**Quality Audit Response Document**  
**Proposed Residential Development**  
**31 & 31A Raven's Rock Road,**  
**Sandyford Business Park, Dublin 18**

## QUALITY AUDIT RESPONSE DOCUMENT

Quality Audit

<b>Document Ref:</b>	<b>P21-148-UQA-GEN-RP-001</b>
----------------------	-------------------------------

#### 3.4.1 Problem

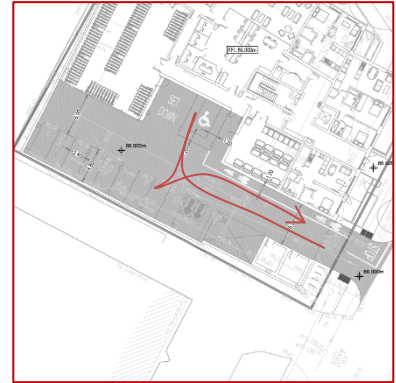
*Summary: It is unclear if emergency, or larger, vehicles will be able to access the development's carpark and if they will be able to safely turn around within the carpark extents.*

Columns have been indicated within the development's carpark which suggest that it is covered, or at least partially covered. It is unclear what clearance will be provided to the soffit and if drivers, particularly those in high sided vehicles (e.g. vans, ambulances etc.), will be warned of the height restriction on approach. If sufficient warning is not provided there is a risk of strikes and material damage.

Additionally, information regarding swept path analysis within the carpark has not been provided and it is therefore unclear if a van or ambulance will be able to safely turn within the carpark.

Measures advising drivers of the height restriction should be provided at the entrance to the carpark where it will be sufficiently visible to approaching drivers. Also, ensure the height restriction does not restrict entry for emergency vehicles, such as ambulances, and that these vehicles can safely enter, turn, and exit the development without striking the building structure, roadside furniture, or parked vehicles.

Signage shall be erected at the entrance to the car park, warning drivers of height restrictions. Sufficient space has been provided within the development car parking area to accommodate the turning manoeuvres of ambulances and other servicing vehicles. Please refer to CS Consulting drawing no. **RR-CSC-XX-XX-DR-C-0007** and **RR-CSC-XX-XX-DR-C-0017** for details of swept path within the development car park.

#### 3.4.2 Problem

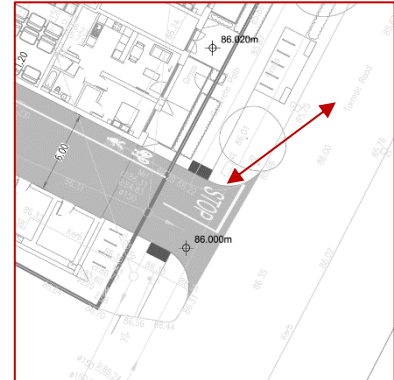
*Summary: A 'Stop' sign has not been indicated at the exit from the proposed development's carpark.*

A 'Stop' sign has not been indicated at the exit from the development's carpark. While 'Stop' text and lining has been indicated on the carriageway there is a risk that this may fade overtime or become obscured during adverse weather.

This could lead to drivers being insufficiently aware of the location of the junction and the need to stop resulting in them failing to come to a stop before entering Ravensrock Road and overshoot type incidents and side-on collisions with vehicles on Ravens Rock Road.

Provide a 'Stop' sign at the carpark exit. Ensure an approaching driver's visibility towards the sign is not restricted by the building boundary or trees.

A 'Stop' sign has been provided at the car park exit as shown on CS Consulting drawing no. **RR-CSC-XX-XX-DR-C-0017**.

**3.4.4 Problem**

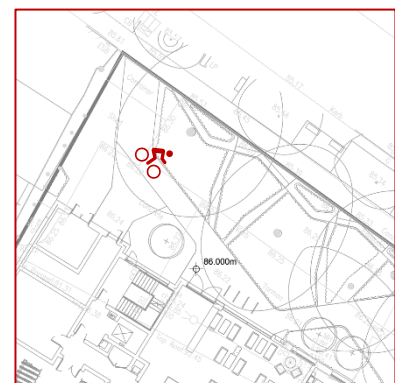
*Summary: The location of the doors to the buildings within the carpark adjacent the development’s access will result in pedestrians exiting directly into the carpark carriageway and possibly into the path of a vehicle entering the development.*

Two buildings/rooms are indicated within the proposed development’s carpark adjacent the access. The doors are indicated such that pedestrians will exit these rooms/buildings directly into the carriageway. Drivers entering the development may have insufficient visibility towards this location and may therefore not anticipate a pedestrian exiting these rooms into their path, resulting in an increased risk of vehicle-pedestrian collisions.

The doors should open into a pedestrian area, away from motorised traffic.

Alternatively, the doors should open from a different location within the building/room.

Doors within the two rooms adjacent to the car park access have been revised to open from a different location within the room and shall now open onto pedestrian only areas. Refer to CS Consulting drawing no. **RR-CSC-XX-XX-DR-C-0017** for details.

**3.4.5 Problem**

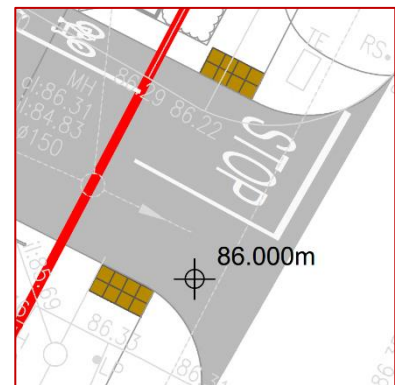
*Summary: Low hanging tree canopies may obstruct vulnerable road users (VRUs) along pedestrian/cycle routes.*

Trees have been indicated within the landscaped area adjacent to the development’s northern boundary. It is however unclear at what height the tree canopy will be mounted relative to the footpath at this location. If there is insufficient clearance beneath the tree canopy, there is a risk that tree branches may present a hazard to VRUs resulting in personal injuries if struck.

Also, during Autumn months, fallen leaves may accumulate within the pedestrian/cycle routes increasing the risk of skidding for cyclists, or slips and falls for pedestrians.

Ensure sufficient vertical clearance for cyclists and pedestrians is provided beneath tree canopies within the development.

Also, a maintenance strategy should be developed ensuring VRU routes within the development are kept clear of obstacles and debris.

Existing tree canopies provide sufficient vertical clearance for cyclists and pedestrians. Additionally, the management company shall be responsible for the upkeep of areas within the site, including removal of fallen leaves to keep paths clear for VRU's. Refer to CS Consulting drawing no. **RR-CSC-XX-XX-DR-C-0017** for details.

#### 3.4.6 Problem

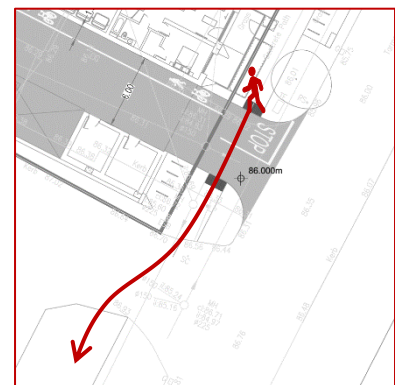
*Summary: Tactile paving at the proposed uncontrolled pedestrian crossing of the development access is not of the required depth.*

An uncontrolled pedestrian crossing has been indicated across the access to the proposed development. The tactile paving on both sides of the crossing is indicated as only two rows of tactile paving deep which is not the required depth for an inline crossing.

This may lead to visually impaired pedestrians stepping over the tactile paving and inadvertently entering the carriageway where there is an increased risk of being struck by a vehicle.

The tactile paving at inline pedestrian crossings should be a minimum of 1.2m (three rows of tactile) deep.

3no. rows of tactile paving have been provided at the pedestrian crossing of the development access junction. Please refer to CS Consulting drawing no. **RR-CSC-XX-XX-DR-C-0005**, **RR-CSC-XX-XX-DR-C-0006**, and **RR-CSC-XX-XX-DR-C-0017** for details.

### 3.4.9 Problem

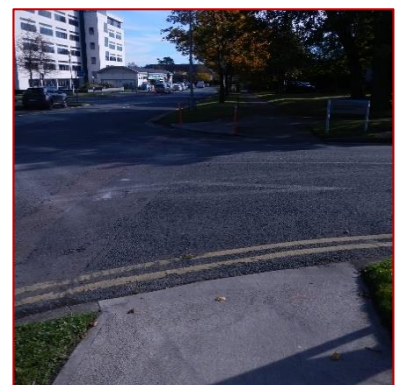
*Summary: It is unclear if the proposed development carpark will sufficiently shed surface water.*

Information regarding the proposed drainage measures within the carpark has not been provided to the Audit Team and it is therefore unclear if the internal carriageways will sufficiently shed surface water. If sufficient drainage measures are not provided there is a risk of ponding within the carriageway which could lead to reduced traction for vehicle wheels and an increased risk of loss of control type incidents or to slips trips and falls for pedestrians during adverse weather.

Ensure the carriageway within the development is sufficiently drained and that ponding does not occur.

The proposed car parking area has been designed to ensure that ponding will not occur. The car parking area shall drain via the proposed stormwater system into the proposed attenuation tank before outfalling into the public stormwater sewer via a proposed petrol interceptor. Please refer to CS Consulting drawing no. **RR-CSC-XX-XX-DR-C-0003** for details.

### 5.2.2 Issue

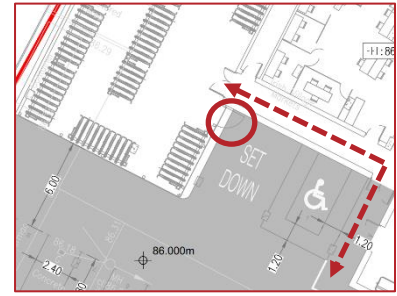
An access to the internal cycle parking facilities from the development's carpark have been indicated to the rear of the proposed Set Down area. Cyclists may be unable to access the cycle parking facilities from this location when the Set Down area is occupied.

If direct access is required from the carpark, the access should be relocated where it will not be blocked by vehicles in the Set Down area.

### 5.2.3 Issue

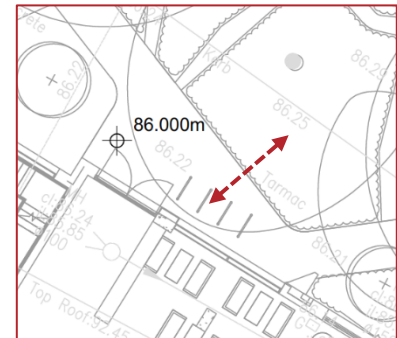
It is unclear if the proposed cycle stands within the development and on the footways on the Ravens Rock Road and Carmanhall Road will be sheltered. Users may be discouraged from using cycle stands if they believe the locations are unsafe, or if their bicycle will be exposed to the weather. This may encourage informal parking on footways or at property accesses, thereby restricting pedestrian access.
